**PCN Attachment
CBE250013
Additional marking
groove PT 2,5
COMBI**

CLIPLINE complete COMBI – Additional marking groove PT 2,5 COMBI

PT 4/1P – additional marking groove existing

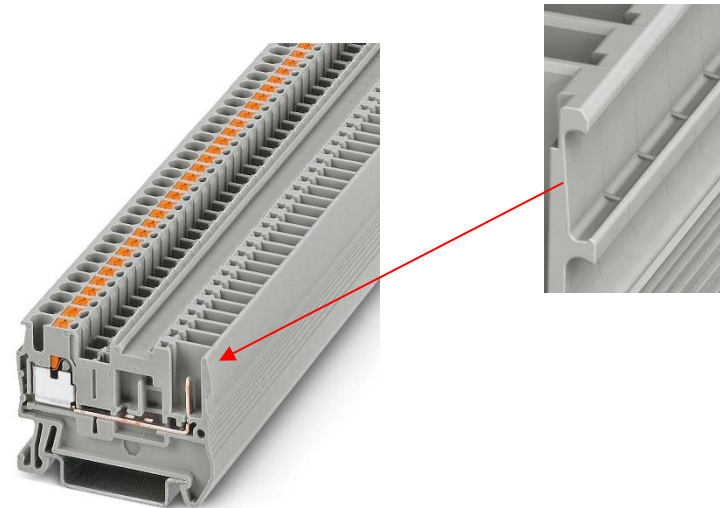
To standardize the CLIPLINE complete COMBI portfolio, the design of the PT 2,5 COMBI terminal blocks will be changed in one detail: The plug zone will be equipped with a marking groove. This feature is already available at several COMBI terminal blocks and beneficial to identify the COMBI connection point in the wiring process of control panels. As an example, the additional marking groove is implemented in the existing PT 4/1P.

PT 2,5-TWIN/1P

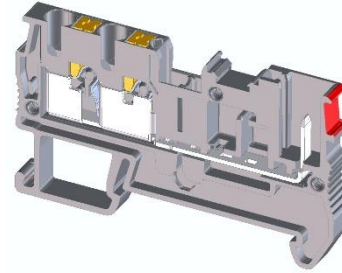
Old & New – Changes in detail(See next slide for complete article list)
